Subject: EMERGENCY EVACUATION TIMES

In response to your requests dated November 29 and December 26, 1979 concerning emergency evacuation times, we are submitting the enclosed map, overlay, table and basis of methodology regarding estimates for evacuation of various areas around WNP 1, 2 and 4 located on the Hanford Reservation in Richland, Washington.

WNP 1, 2- & 4

EVACUATION TIMES

WASHINGTON PUBLIC POWER SUPPLY SYSTEM	
WPPSS 10 MILE EMERGENCY PLANNING ZONE MAP	
PROJECT NO.	1, 2, 4
DATE	FEB 1978
BY	F-W-T-020
REVISION	1

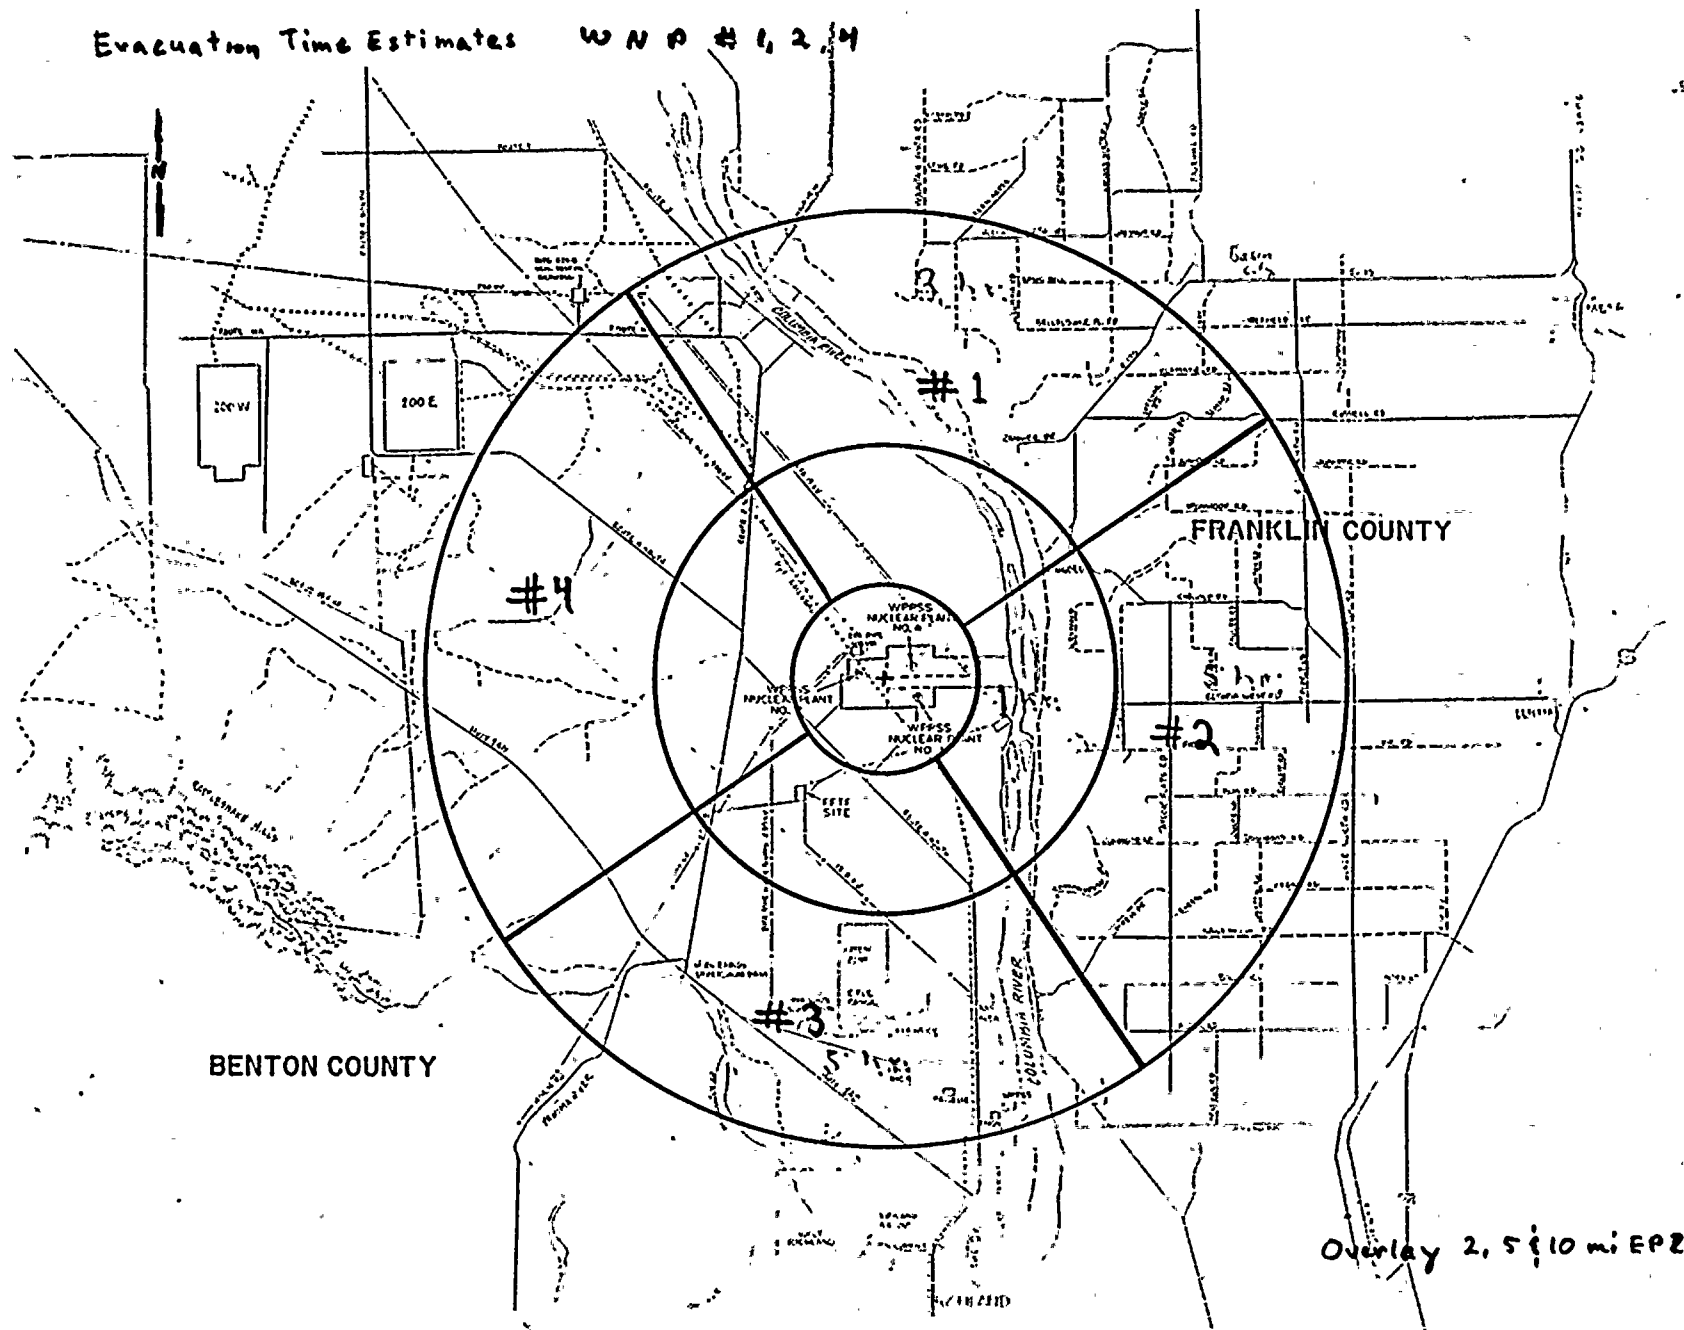
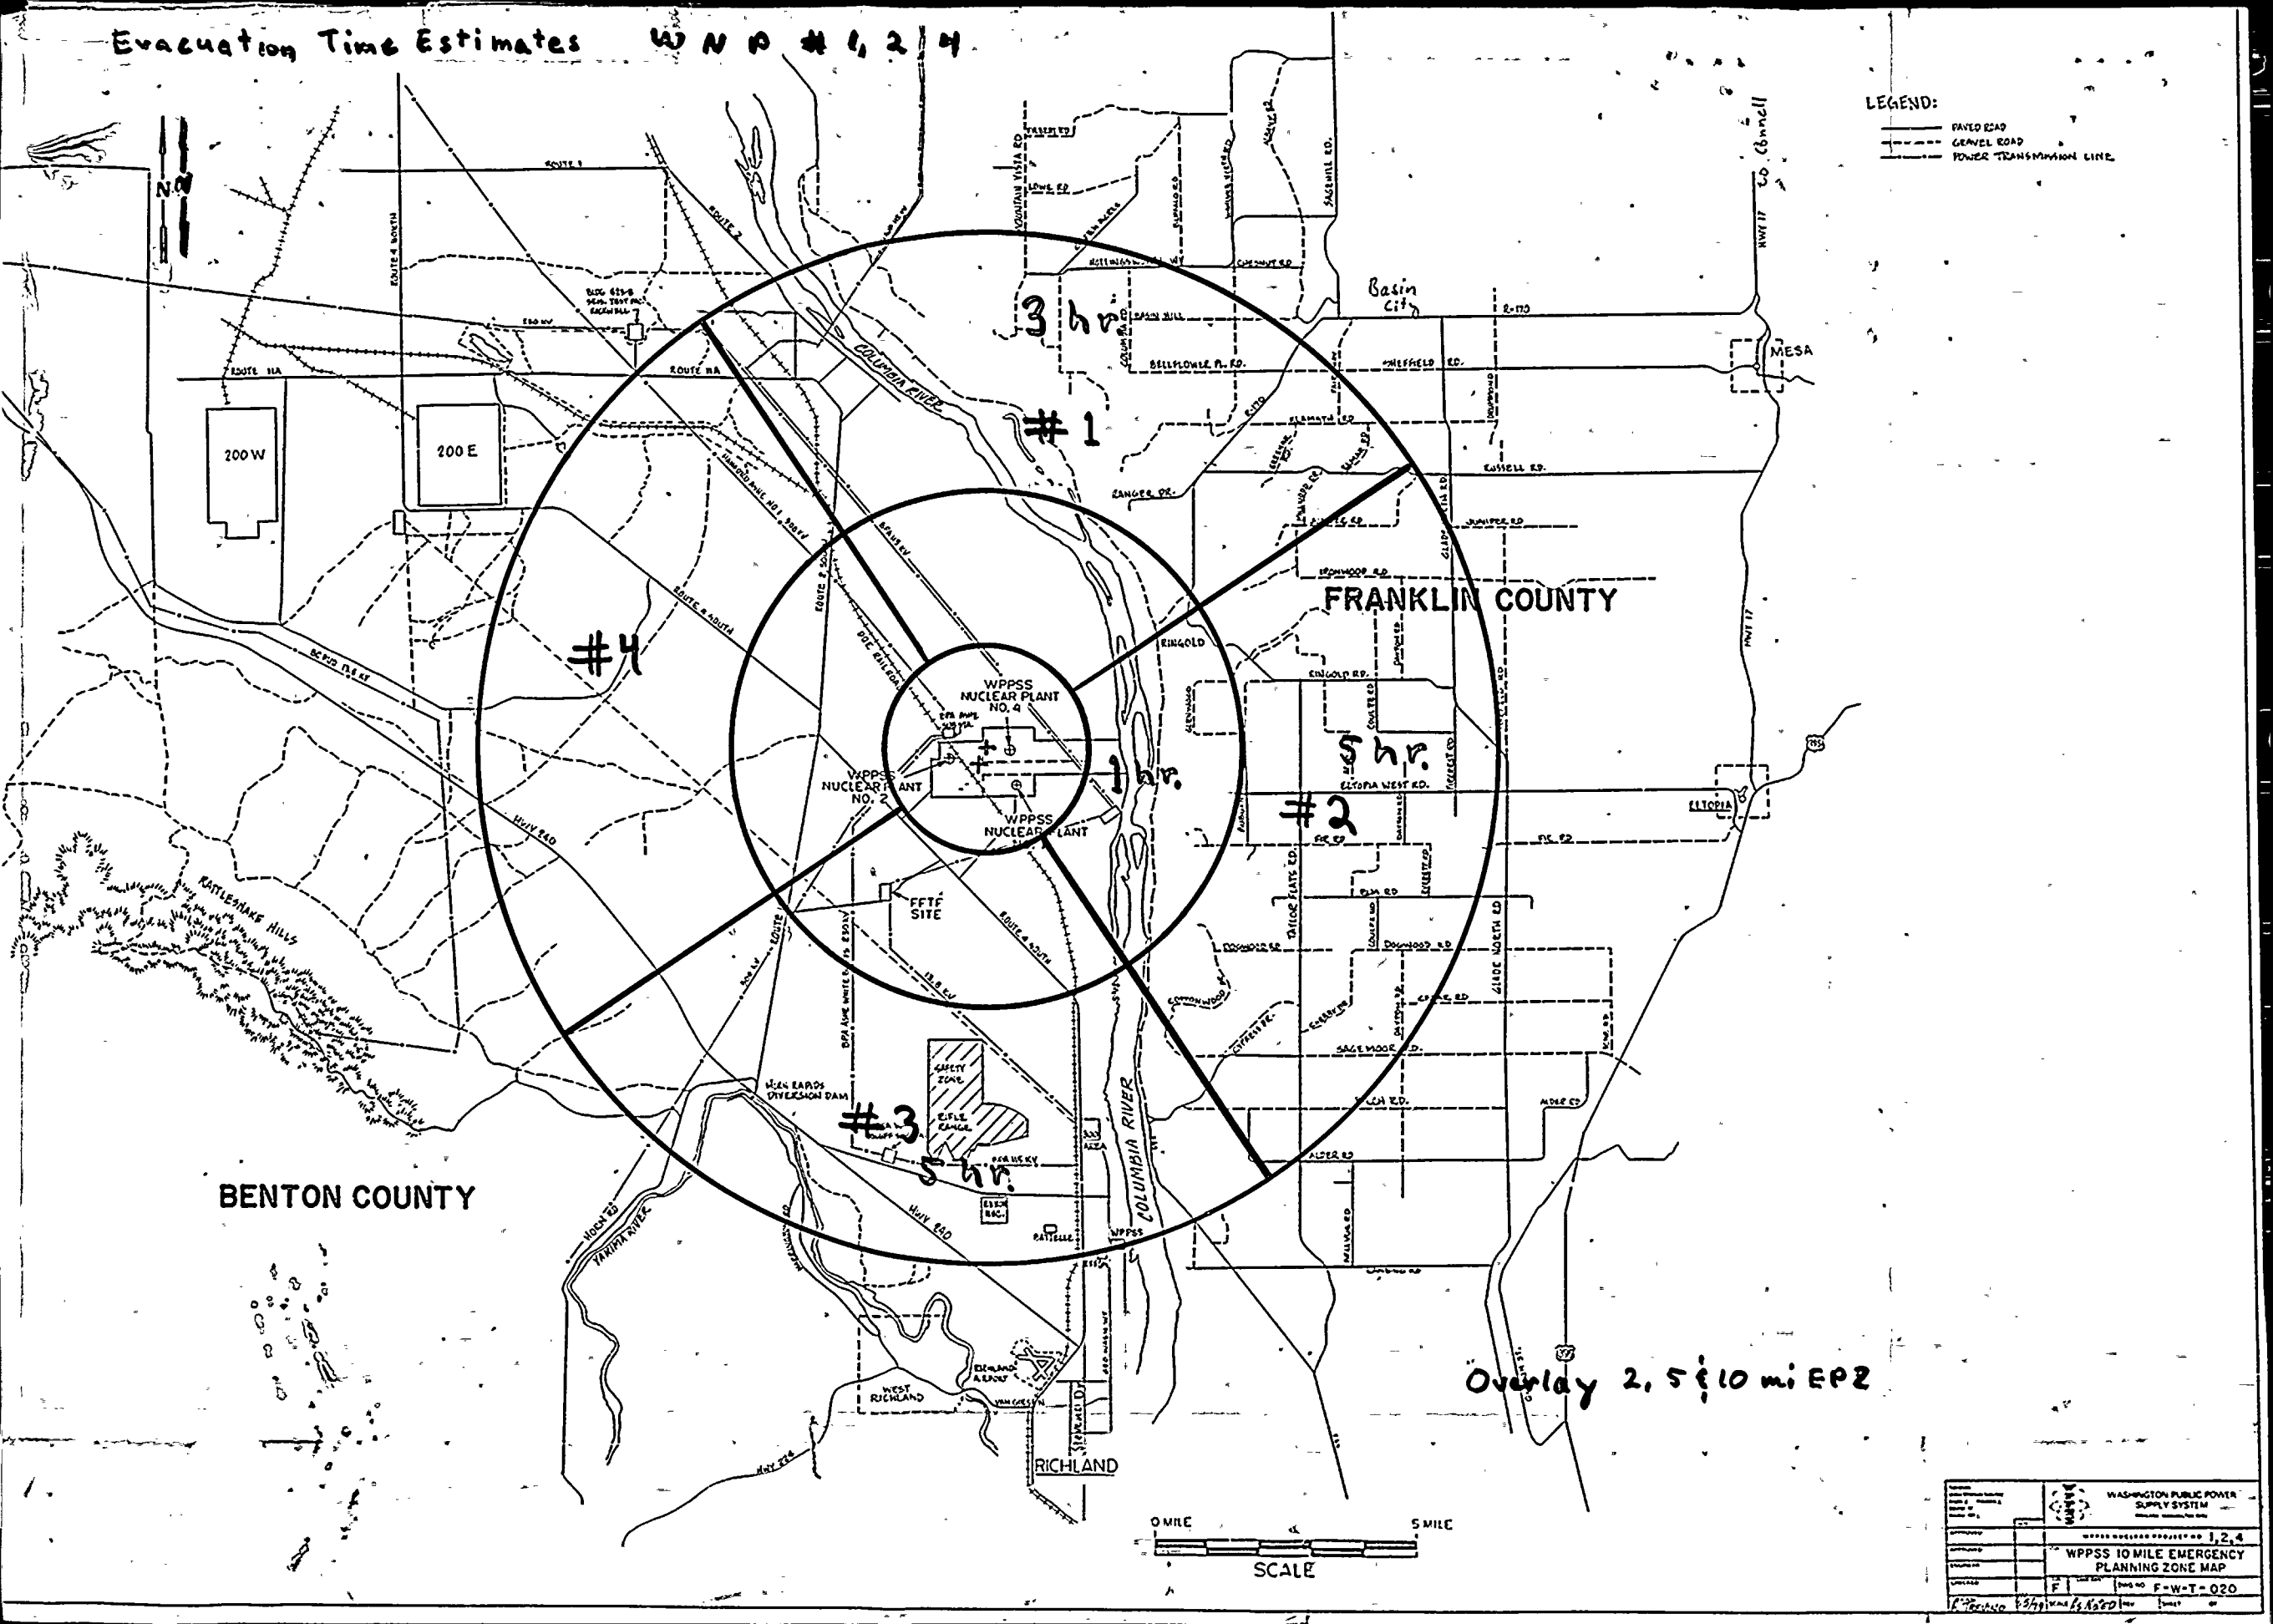
Two estimates are requested in each of the areas defined in item 1 for a general evacuation of the population (not including special facilities). A best estimate is required and an adverse weather estimate is required for movement of the population.

Where special evacuation problems are identified (e.g., in high population density areas), specify alternative protective actions, such as sheltering, which would reduce exposures and the effectiveness of these measures.

Attached is a table of populations, population densities and evacuation times. A map with an overlay of the 2 mile, 5 mile, and 10 mile sectors with times indicated is also attached. The evacuation times are for normal weather conditions and include shutdown and mobilization times for farms which takes longer than in densely populated areas.

No area is identified where special evacuation problems may exist. As can be seen on the attached table and map overlay, all areas within the 10 mile EPZ have very low populations.
